ATTACHMENT 1

City of Ryde Submission Woolworths CFC and Warehouse, 144 Wicks Road Macquarie Park

SSD-48853239

**Submission Date: 05 June 2025
COR2023/61/1**

Figure 1: Markup of Open Space Network Map Figure 18a (Base Source: Macquarie Park Design Guide)

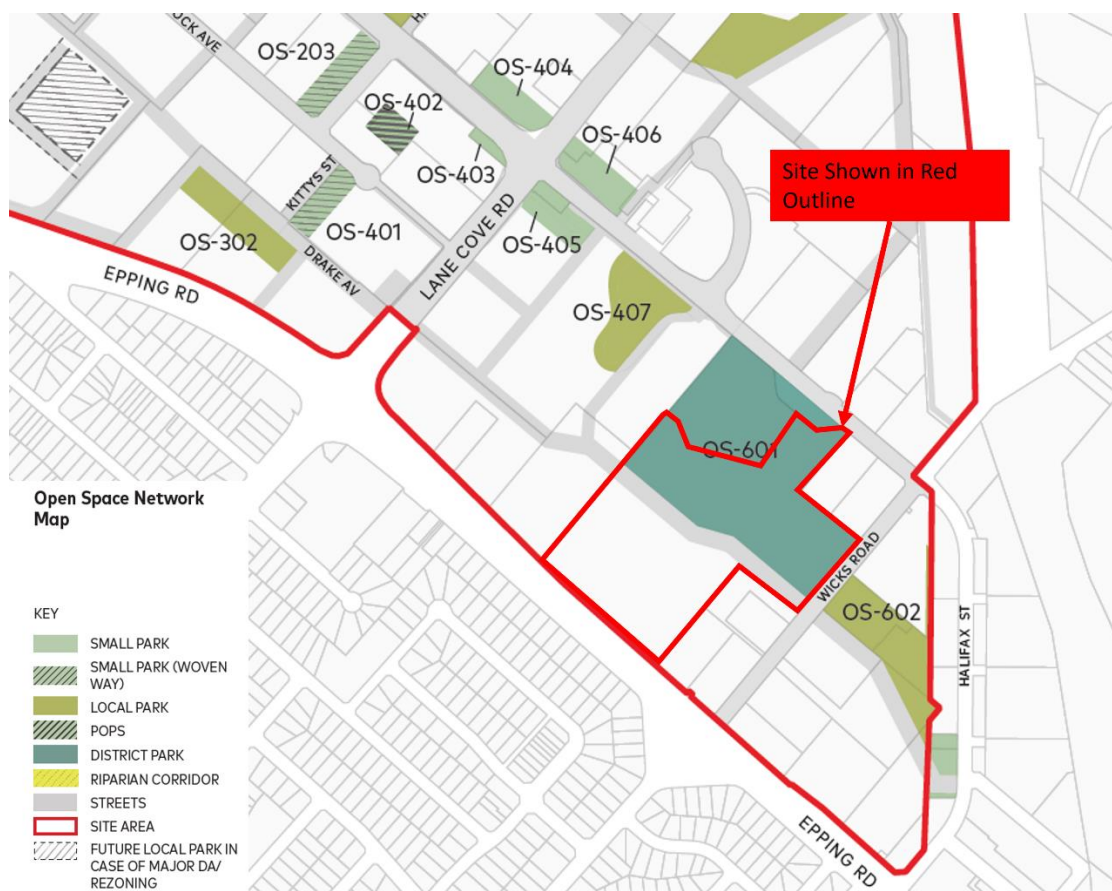
Figure 1 shows the district park identified on the site under the Macquarie Park Design Guide (Design Guide), that the current application does not propose the dedication to Council. Council considers that the current application must provide the district park as outlined in the Design Guide as if its not provided then the large planned open space in Macquarie Park will never be delivered and the planned population growth under the rezoning of Macquarie Park, will face an even worse open space shortage then it already does. While the proposal does not preclude future provision of public open space, it relies on the argument that the development complies with existing planning controls and does not itself generate additional demand.

Given that the site exceeds the base planning provisions and is therefore utilising the incentive provisions of key site 10, Council considers that the subject application must provide the open space. Should the open space not be dedicated to Council, and the warehouse constructed, the planned open space will likely be locked out of delivery for the entire lifecycle of the warehouse facility until its redeveloped again in the future, which may be 50 years or more. This outcome is unacceptable and must be resolved by the subject application.

The Application does not effectively address the community need for the site accommodating public open space that supports the cultural, recreational, social, and biodiversity needs of the local community through improved open space.

- The application proposes the dedication of the district park as required in the Design Guide.
- Engagement occurs with Council in respect of a proposed Planning Agreement for the dedication of the open space.

Figure 2: Mark up of Design Guide Structure Plan (Base Source: Macquarie Park Design Guide)

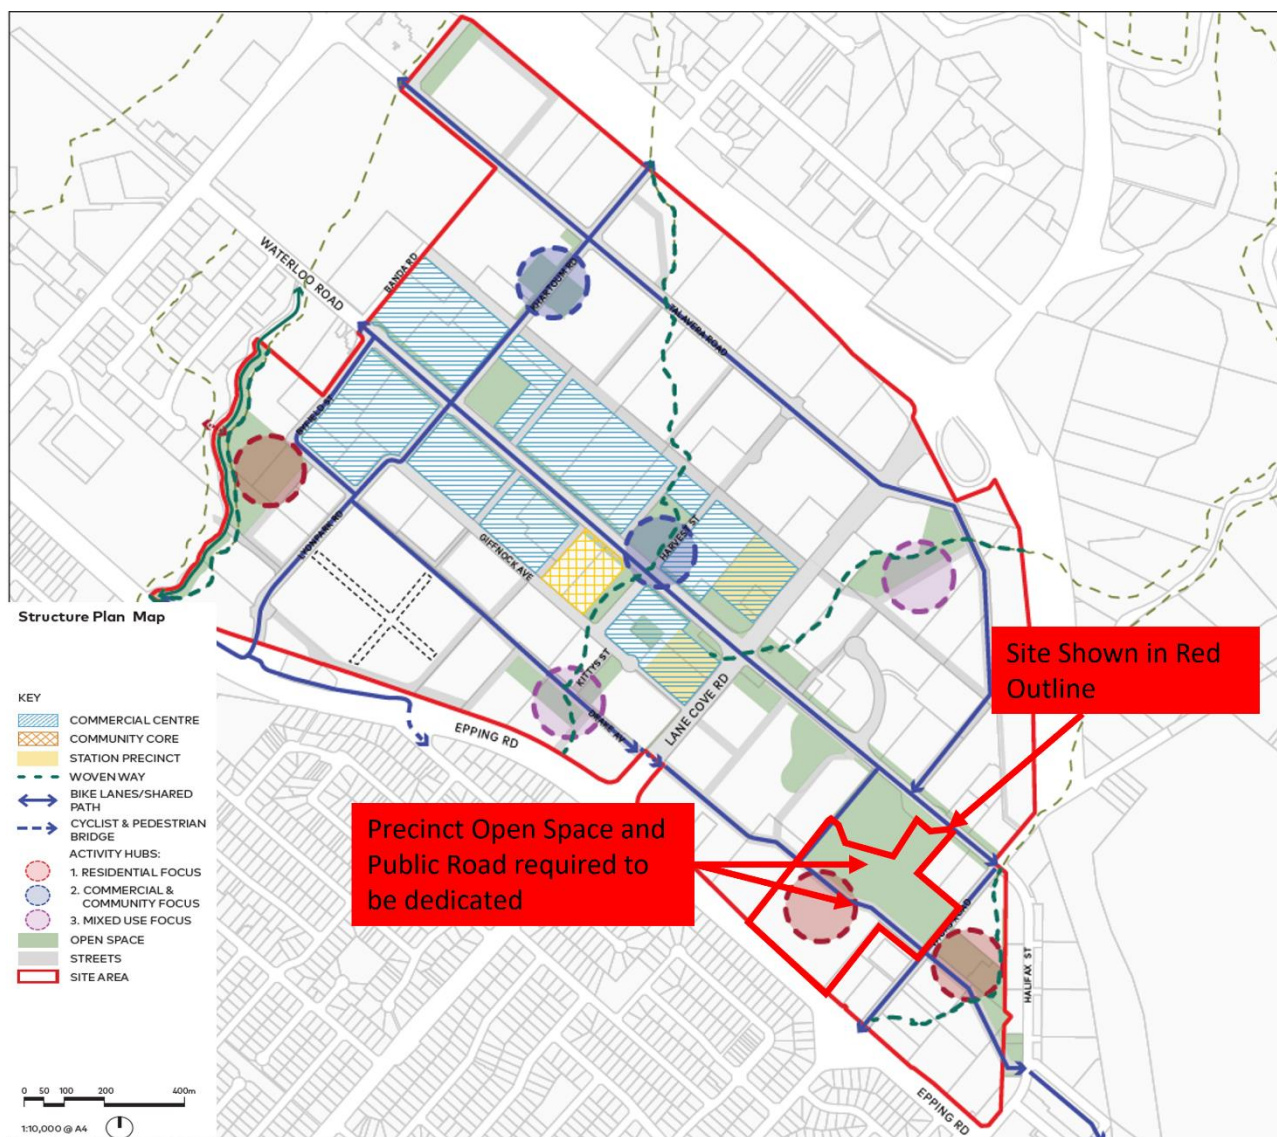
The driving principles behind the structure plan is to address the “acute deficit of open space” in the precinct. The subject application is exacerbating this acute deficiency by not proposing the dedication of the open space, which is not supported. Figure 2 shows the site is to provide the precinct open space and public road, which the subject application does not provide.

Should the above not be provided, Council considers that the application is inconsistent with the provisions two (2) and three (3) of Section 2.4 of the Design Guide.

- 1) Provide the dedication of the open space
- 2) Provide the primary road

Figure 3: Markup of Figure 16A Through site links (Base Source: Macquarie Park Design Guide)

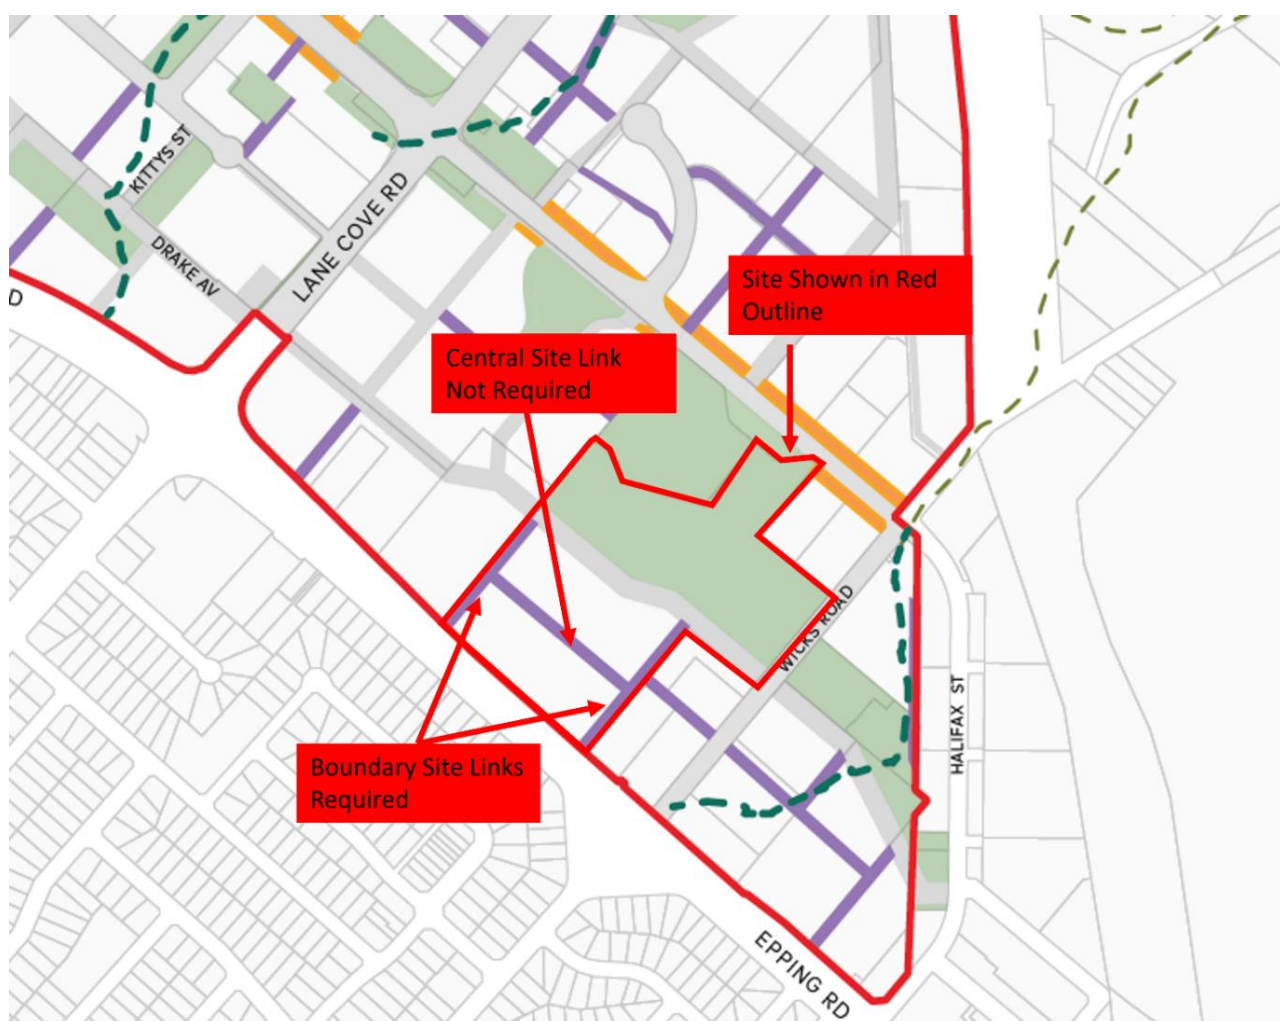
Council notes that the application is entirely inconsistent with the design guide as:

- It does not propose the construction and deliver of the through site links
- The through site links will not meet the design requirements of Figure 17 of the design guide.

Noting that the boundary site links are to be designed as a 12m in width, Council considers that reduced widths can be considered as acceptable given the nature of the proposed use. Whilst the design guides principles were only developed considering this site was residential in nature, given the commercial aspect and the nature of the land use. Any site links must be designed to consider surveillance and safety considerations for pedestrians using these links.

- Detailed Plans are provided for the proposed construction and delivery of the site links.
- Public access easements are to be placed on the proposed site links.
 - Council notes that LDA2015/0144 required 6m site links and imposed conditions requiring public access easements be created.

Figure 4: Mark up of Land Dedication Map (Base Source: Macquarie Park Design Guide)

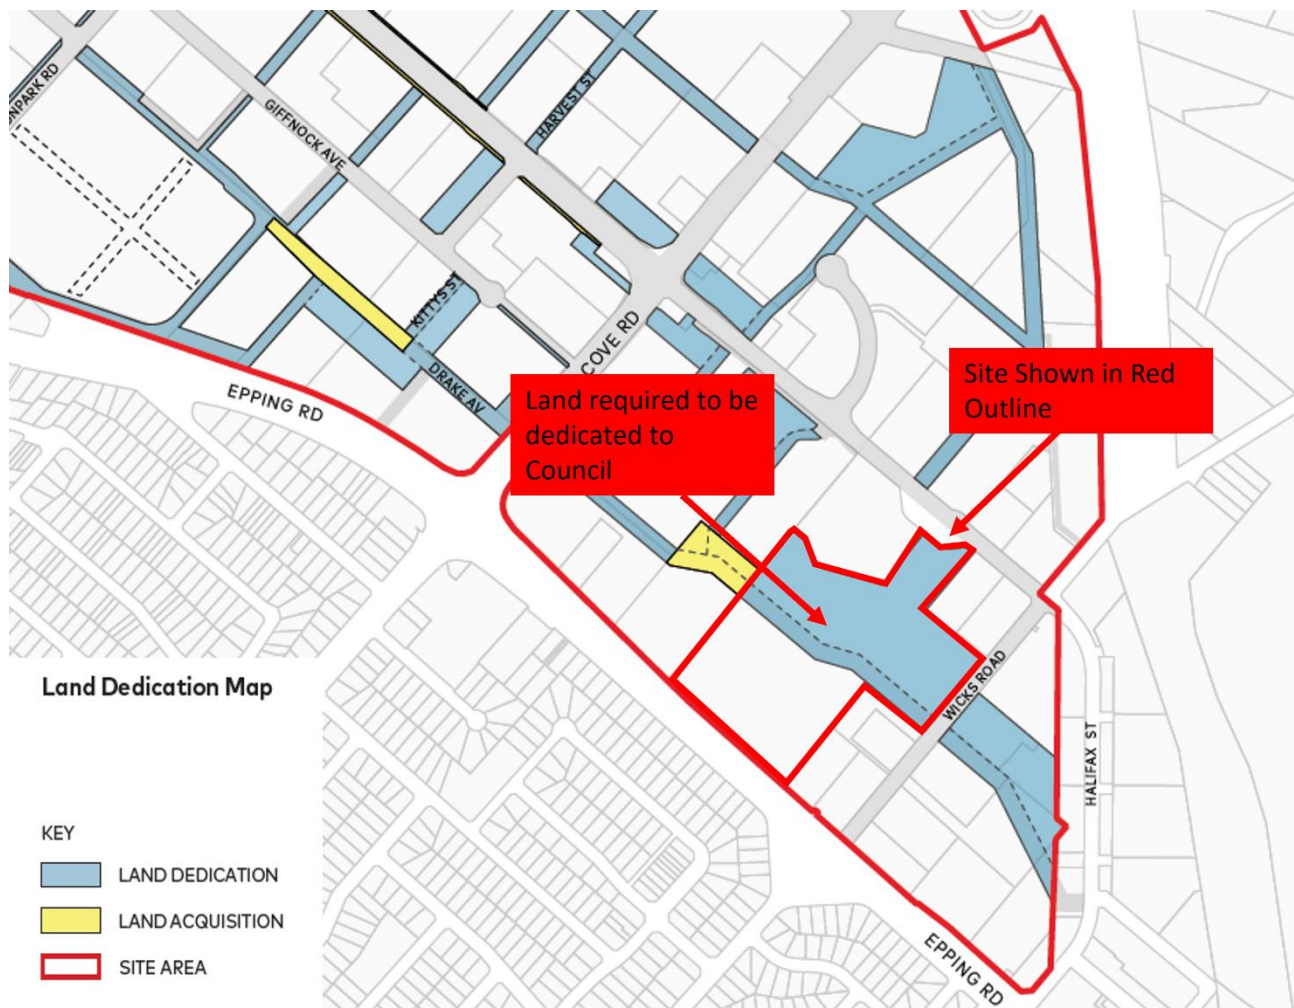
Based on the provisions of Section 4.3, the applicant is required to dedicate the land shown in Figure 4 to Council. The provisions state unless by agreement by Council they can be kept in private owned publicly open space. No agreement has been made with Council, nor does Council support this open space being privately owned.

Council seeks that the applicant engage with Council in respect of a planning agreement to facilitate the dedication of land required under the Design Guide and Key site provisions.

Figure 5: Extract showing the scale of the direct to boot service: (Source: Nettleton Tribe)

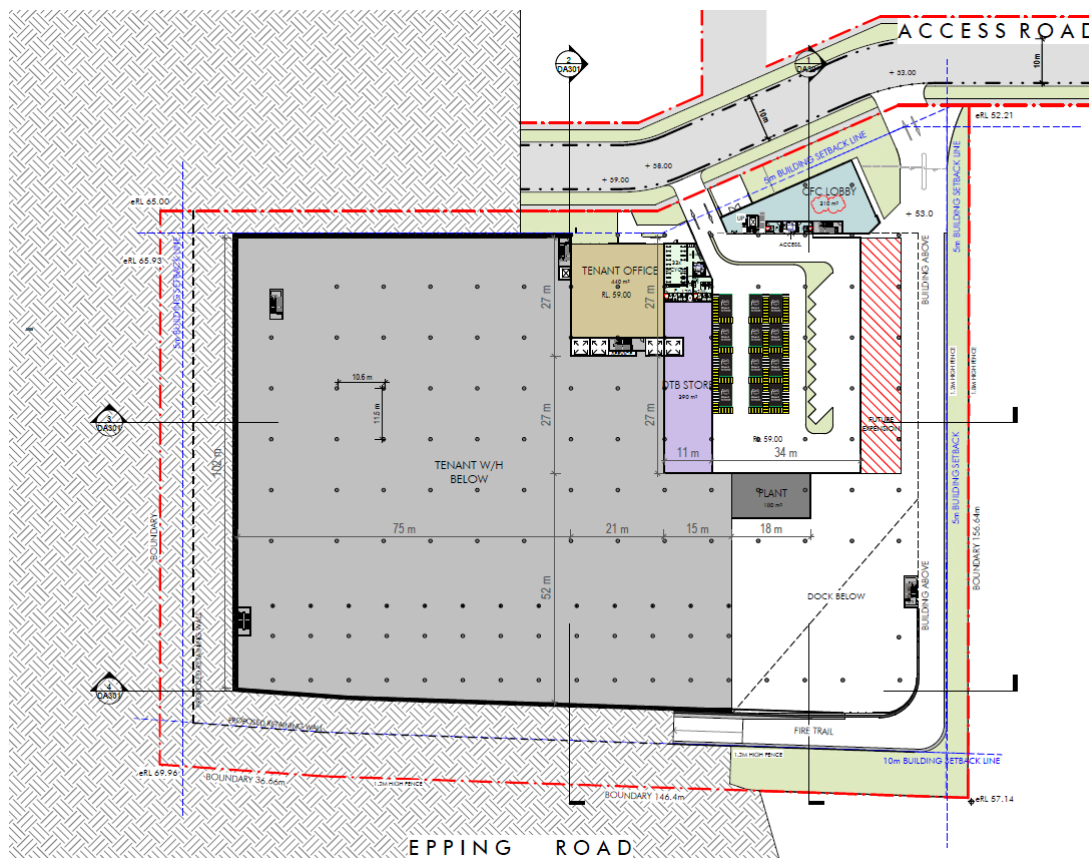
In consideration of the definition of the Warehouse and Distribution centre, Council notes that the proposed "Direct to Boot" service proposed, that is separate from the warehouse function. It's understood that the direct to boot service operates in a manner that has members of the public place orders online and attend the site in person to directly pick up the items ordered.

Based on the above, the direct to boot service proposes a retail sales operating from the site which does not accurately fit within the definition of a Warehouse and Distribution.

It is unclear the scale of the Direct to Boot Service, however based on the size, location on the site, amount of parking spaces and possible operational practices it does not appear to be an ancillary function and would be its own primary purpose separate from the Warehouse component.

The Direct to Boot service does not accurately fit within the definition of a Warehouse and Distribution centre, and is most accurately defined as a “Specialised Retail Premises”, which is defined as:

As a specialised retail premises is not development that is considered State Significant and the issued SEARs does not relate to the specialised retail premises, the ‘use’ of the site for such purpose requires consideration under a separate consent. Council recommends that should the application be approved; a condition be imposed that requires a separate consent for “use” be sought from Council regarding the direct to boot proposal.

Figure 7: Extract showing Flood Affected Land and Council Drainage Assets (Source: Ryde Maps)

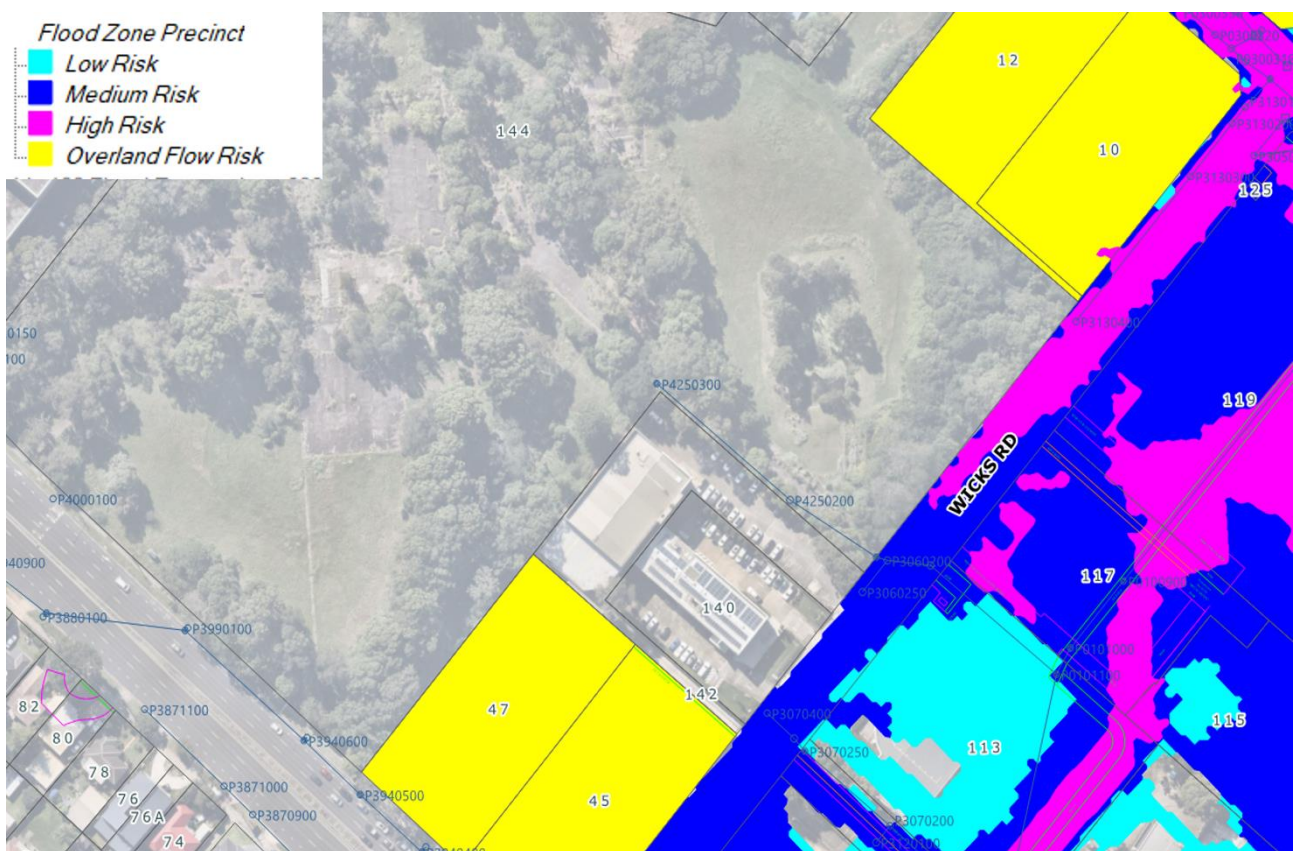
- Update the plan to show the existing Council drainage asset (refer Figure 6)
- Ensure adequate clearance is maintained from Council drainage assets. Where no easement is registered over a Council pipe, a notional (pretend) easement of 3 m must be shown on the plans for pipes less than 1350 mm in diameter. The easement is to be centred over the pipe alignment.
- Ensure the ownership of the road and drainage assets is clearly noted on the plan. Also, indicate the maintenance and ownership responsibilities for the GPT.

4. Existing Council drainage infrastructure details including, diameter, etc. shall be shown on the plans.
Note: Please use Council asset numbers.
5. Details of the connection to Council pits/ pipe shall be included in the Stormwater Management Plan.

6. Minimum 1% slope to be proposed for new drainage lines in Council land.
7. Council Details shall be incorporated, from Council Standard Drawings.

Figure 8: Mark up of Street Network (Base Source: Macquarie Park Design Guide)

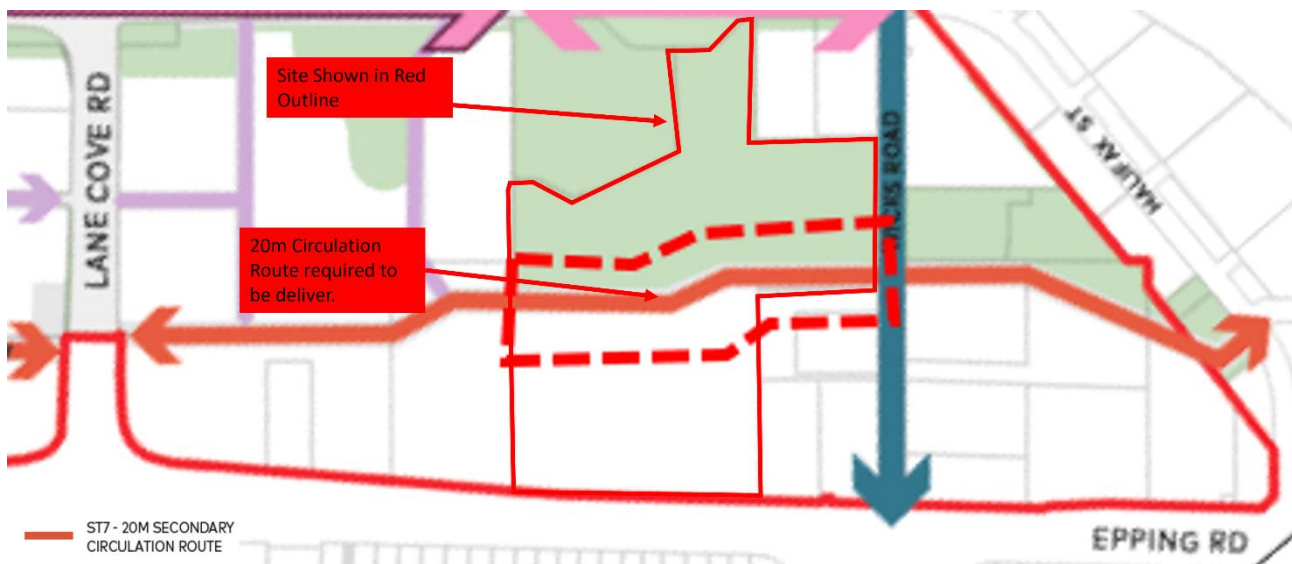
A new 20m width road extending Wicks Road, adjoining the southern boundary of Lots A and B and culminating in a cul-de-sac arrangement in the south western corner of Lot A.

The alignment and width appear to comply with the requirements of the Updated Design Guide. As noted earlier the applicant does not propose the dedication of this road consistent with the design guide to Council. Council seeks that the applicant engage with Council for the dedication and deliver of this road.
